Integra Underground Project (MP 8_0101)

Collated Response to Submissions

Integra Coal Operations Pty Ltd

March 2010

Figure 1

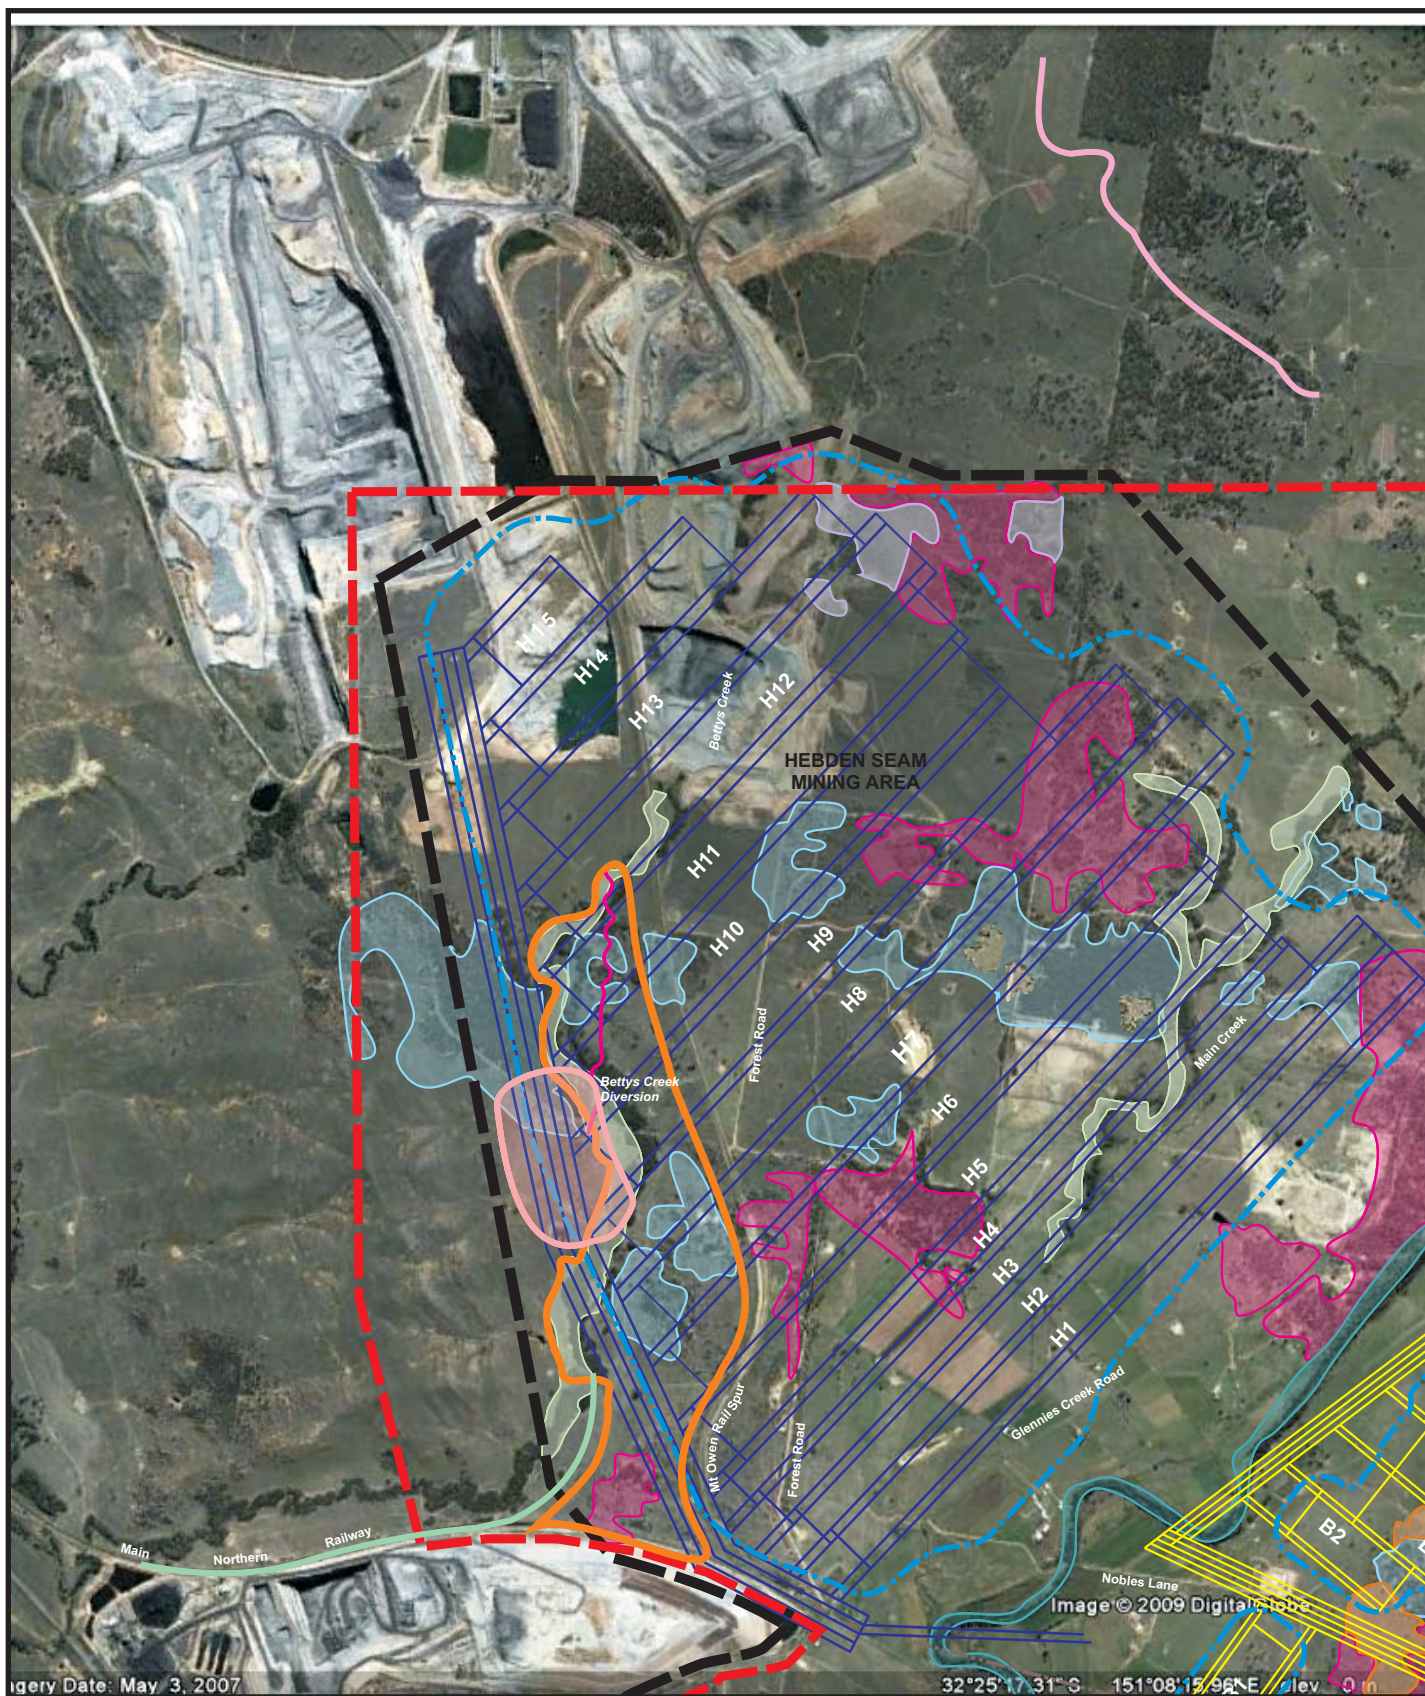
Figure 3.4 of Volume 1 of the EA depicts potential additional ventilation shaft locations to the north-west and south-east of the existing Forest Road Ventilation Shaft Area (ML 1525). The potential area proposed to the north-west is overlayed on both the Central Hunter Swamp Oak Forest and Central Hunter Bulloak Forest as well as the Glendell Biodiversity offset Area. ERM states that 'to the greatest extent practical, infrastructure will be sited to avoid impacts to vegetation'. However this is not considered to be a solid commitment by the proponent and leaves DECCW unable to assess the actual impact of progressive vegetation clearing.

The Integra Underground Mine currently operates an existing ventilation shaft near Forest Road. The proposal identifies that an additional ventilation shaft may be required to enable Hebden seam mining activities. Two potential locations for the additional ventilation shaft are identified on *Figure 3.4 of Volume 1 of the EA* as envelopes within which this disturbance may occur. A review of *Figure 3.4* shows that the envelope to the northwest of the existing Forest Road site approximates 50ha whereas the actual area of disturbance required for a new shaft and associated infrastructure would, based on the existing facility, be unlikely to exceed two hectares.

Figure 1 (attached) overlays the proposed ventilation site envelope over EA Figure 15.3 (updated to reflect the presence of the Eastern Rail Pit and associated diversion of Bettys Creek) and shows that extensive areas within the identified envelope are available for ventilation shaft installation which would impact on neither the Glendell Habitat Management Area nor mapped Swamp Oak or Bulloak communities.

Figure 2

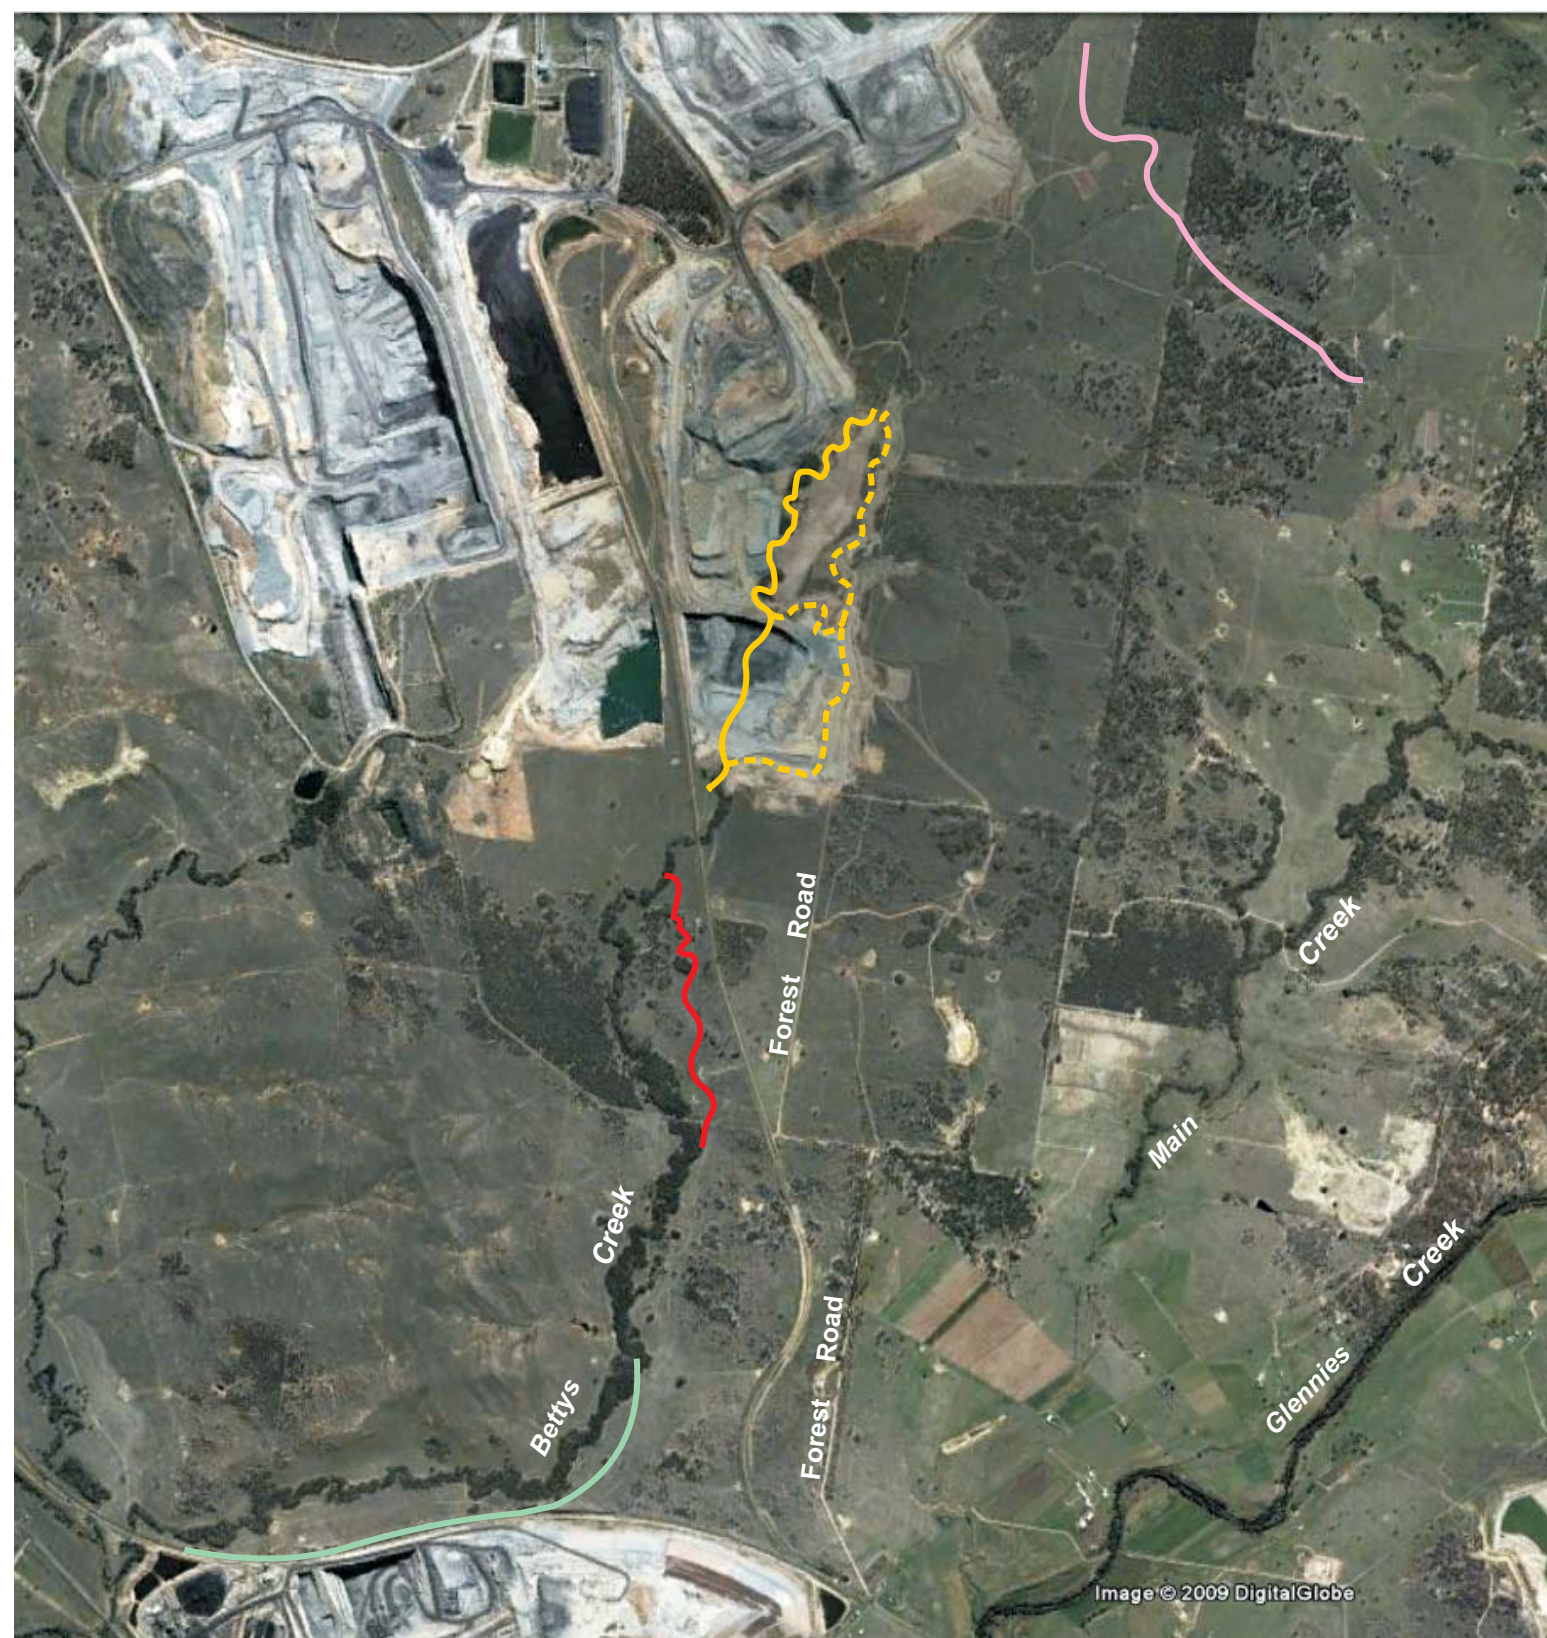
DECCW considers that the significant change in floristic composition which is likely to occur does ultimately represent a loss of this regionally significant community (and potential EEC). It is also considered that the success of this revegetation cannot be assured and therefore it is highly likely that this vegetation will be permanently modified. This modification therefore has the potential to impact on habitat connectivity for arboreal threatened species such as the Squirrel Glider and Brush-tailed Phascogale which have been recorded in the northern portion of the Project Area.

As discussed in Section 5.1 of the Integra Underground Coal Project Flora and Fauna Assessment (ERM 2009) (Annex K of the EA report), the proposed Bettys Creek diversion will extend some 1400 metres and will meander within the confines of a constructed floodplain.

Construction of the diversion will be a dynamic process and may involve pre-emptive works as well as earthworks at the same time as or following mining. However, although limited diversion construction activities may commence prior to or following the completion of Hebden Longwall 9 (ie around 2019) in order to drain any areas of local subsidence-induced ponding, and be undertaken progressively as mining advances through Longwalls 10-12, the south to north progression of the longwalls would mean that the diversion is unlikely to be fully functional prior to the cessation of mining in Hebden Longwall 14, ie around 2022 or some eight years following the commencement of Hebden Seam longwall extraction. Prior to that time, some flows would continue down the existing alignment.

Species composition within the section of Bettys Creek cut off from natural surface flows may alter over time and, as a worst case, may ultimately comprise a suite of species more suited to the new environment and the resultant loss of up to five hectares (ha) of the *Casuarina glauca* component of the Central Hunter Swamp Oak Forest. However, Rough-barked Apple and Forest Red Gum are not dependent on free groundwater and no losses in these species are predicted: as noted previously, these species are ubiquitous across the local landscape including on ridges and flats. It should also be noted that while underground coal extraction is predicted to lower the alluvial groundwater table (albeit generally within the natural variability range experienced since January 2002), the magnitude of the predicted loss is such that the alluvial groundwater may well continue to provide some water resource for *Casuarina glauca*. Even should the entire *Casuarina glauca* component of the community along the bypassed section of channel decline in the long term: the likely replacement of these by other species, the predicted retention of the non-groundwater dependent Forest Red Gum and Rough-barked Apple, and the growth in the Glendell Habitat Management Zones and new channel are expected to provide habitat connectivity for arboreal threatened species.

Figure 3

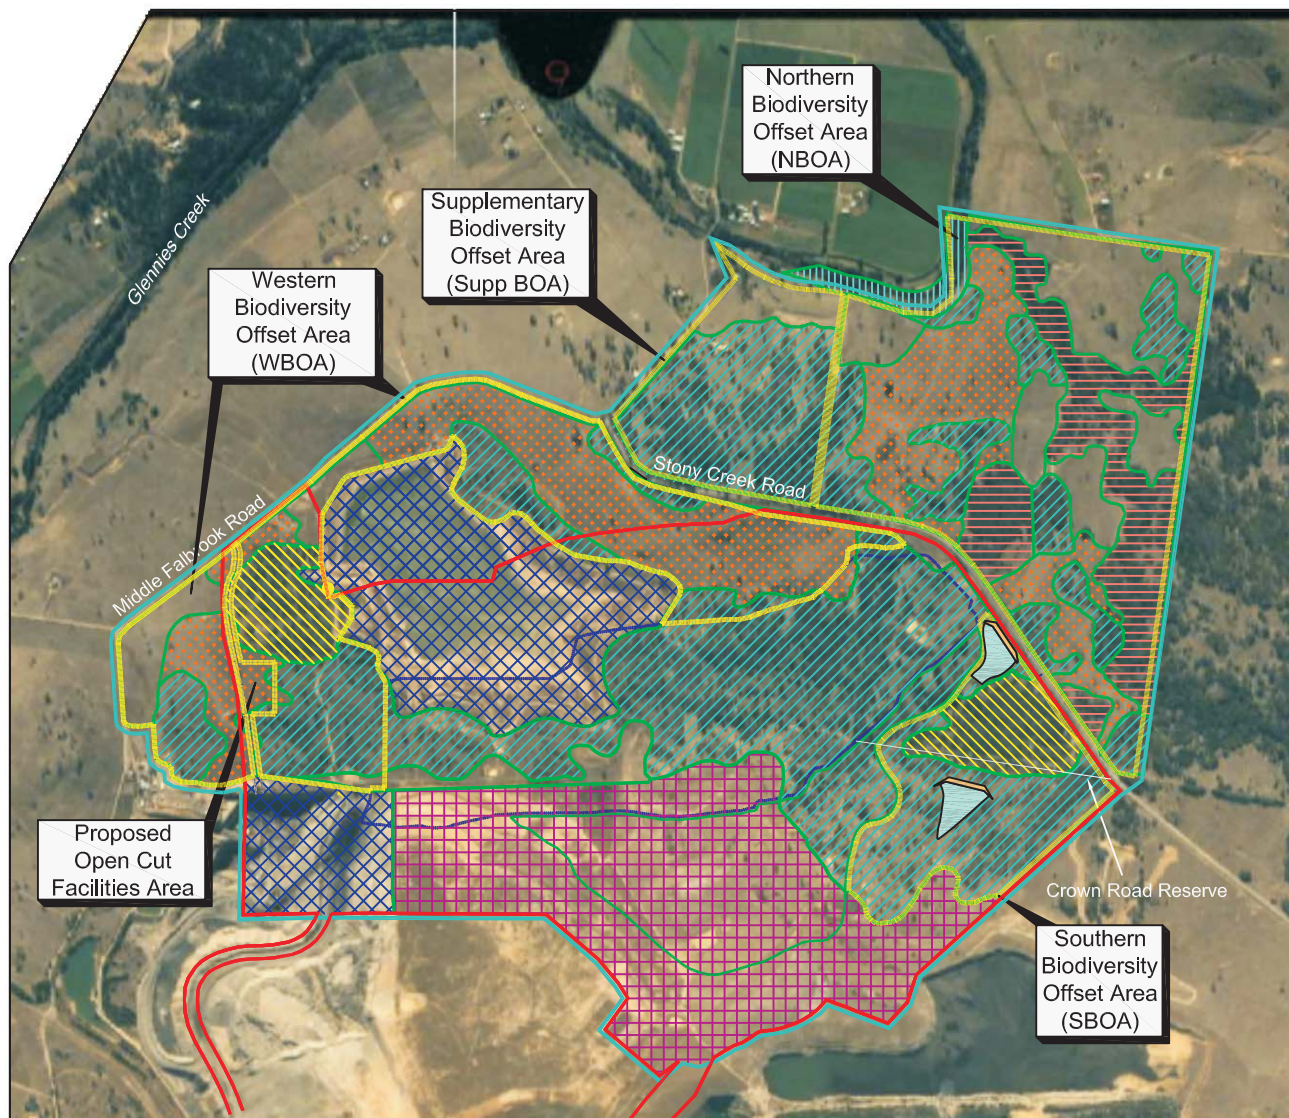
The current version of the Ecological Assessment does not propose any offset or compensatory measures for the loss of vegetation as a result of the Bettys Creek diversion or potential additional ventilation and bore hole location, instead relying on previous offsets relating to the Integra North open Cut. As stated in DECCW's 'Principles for the use of Biodiversity Offsets in NSW', offsets must be supplementary. They must be beyond existing requirements and not already funded under another scheme.

Due to the lack of certainty relating to the impacts of subsidence, as well as the potential loss/significant modification to a regionally significant vegetation community and threatened species habitat, the precautionary principle should be applied. Future offsetting of the long term impacts on biodiversity therefore needs to be addressed.

As stated in Section 6.3 of Annex K of the EA, ICO proposes that the potential loss of five hectares of the regionally significant Central Hunter Swamp Oak Forest be offset within the 33.4 hectares of this community in the Northern Biodiversity Offset Area negotiated for the Glennies Creek (North) Open Cut proposal (see Figure 3 attached). Although the proposed area lies within the previously nominated offset area, adoption of this approach is not inconsistent with the Principles for Use of Biodiversity Offsets in NSW: the requirement for an offset associated with the North Open Cut was primarily a consequence of the planned clearing of 68ha of Narrow-leaved Ironbark-Spotted Gum-Forest Red Gum Community. (Note that the North Open Cut mine does not clear any Swamp Oak community). That the clearing of this community was the basis for the North Open Cut Mine offset is also demonstrated by the specific reference in PA 06-0073 “...to acquire additional lands to supplement the offset strategy to ensure provision of as least 140ha Narrow-leaved Ironbark-Spotted Gum-Forest Red Gum (or a suitable equivalent to be agreed with DECC)”. The fact that 33.4 ha of Central Hunter Swamp Oak Forest was included in the offset area was purely a consequence of the manner in which ICO defined the offset area, ie rather than pockets of the Narrow-leaved Ironbark-Spotted Gum-Forest Red Gum community for the offset, it was considered more appropriate to define the area using a cadastral boundary. This 33.4 hectare area of Central Hunter Swamp Oak Forest as shown on Figure 3 will be retained as an offset to the potential loss of 5 hectares along the bypassed section of Bettys Creek.
